DRAWING AMENDMENTS

RF POWER LDMOS TRANSISTOR WITH MULTIPLE GATE FINGERS

Inventors: Jan Johansson et al. Attorney Docket.: 068758.0136

Annotated Page 1 of 2

Fig. 1

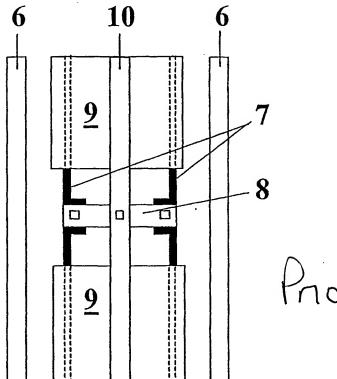
The drawings were objected to for failing to show every feature of the invention as specified in the claims. Please replace Drawing Sheets 1, Figures 1-2 with replacement Drawing Sheets 1, Figures 1-2. Applicants also submit annotated red-lined drawing pages reflecting the changes. Applicants provide formal corrected drawings to be entered if the proposed changes are accepted by the Examiner.

Examiner has objected to the drawings for not showing every feature of the invention specified in the Claims under 37 CFR 1.83(a). Applicants enclose substitute drawings for the Examiner's review and approval.
